**2B. Public Hearing - Consideration of a request for a Preliminary Plat for Jefferson Commons Fifth Addition and Conditional Use Permits for Cross-Access on a 7.01 acre site in a B-4 (Regional Business) district, for a Day Care Center use. Applicant: Kid’s Haven Childcare and Preschool**

**ALTERNATIVE ACTIONS**

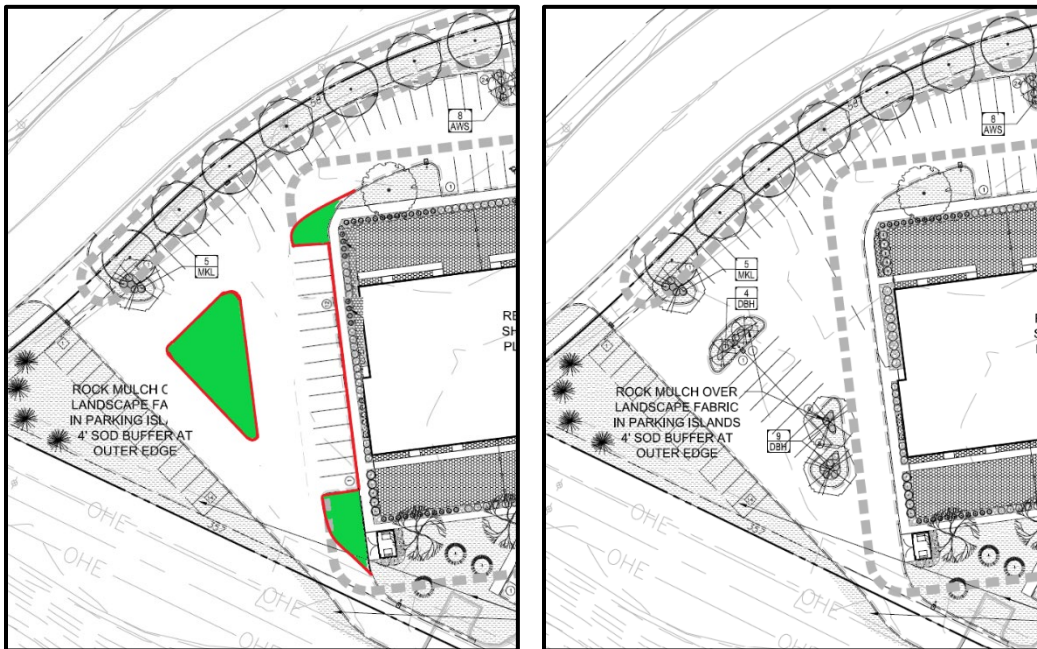
As a permitted use, an administrative site plan review is required for the use itself. The applicants have prepared site plans to demonstrate the ability to develop the proposed use on the subdivided property. Staff completed a site plan review concurrent with the land use applications and included the site plan review comments here for reference.
